**City of Bellevue
Development Services Department
Land Use Staff Report**

Proposal Name: Heitz Short Plat

File Number: 10-124865-LN

Department Decision: **Approval with Conditions**

Figure 1 – Preliminary Short Plat Proposal

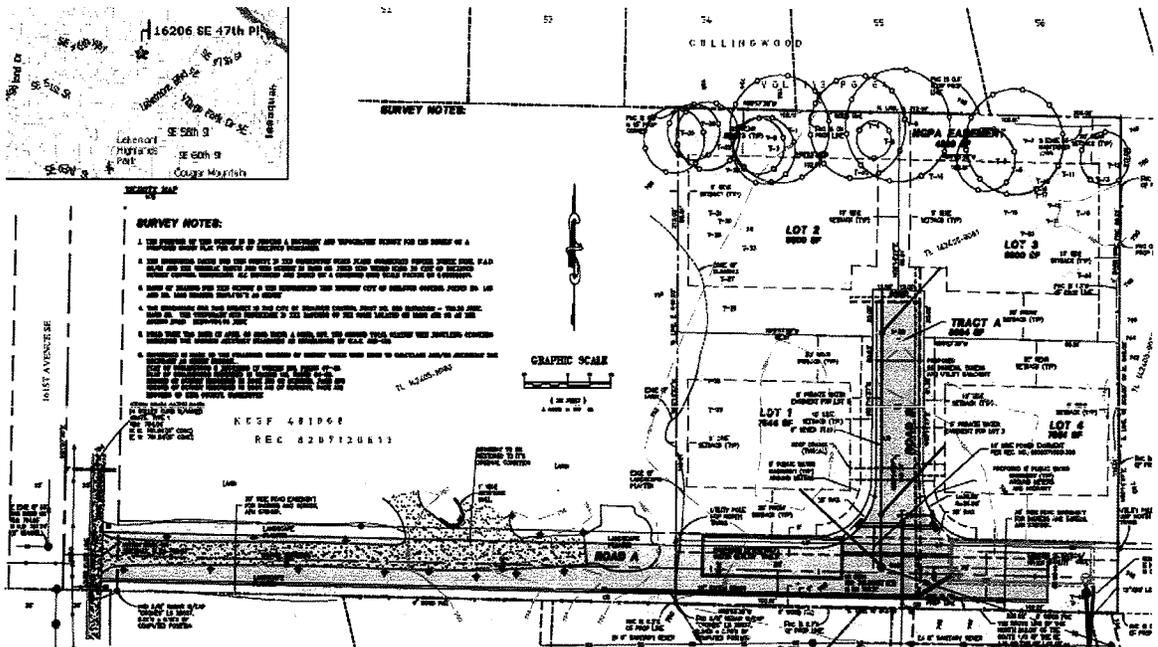
5. The proposed access road will require a turnaround with leg radius of 60 feet from centerline of perpendicular road. If the road extends over the storm water detention tank, as shown, the tank shall be designed to support fire vehicles.

6. The hydrant location shown at the turnaround may meet the design requirement; 150ft to any portion of the structure as the hose would be extended; depending on design of the houses. The homes may require automatic sprinkler protection per NFPA 13D depending on the square footage of the house and the fire flow available at the hydrant. If sprinklers are installed a 1inch water meter is the minimum size, this will be determined during the building permit stage.
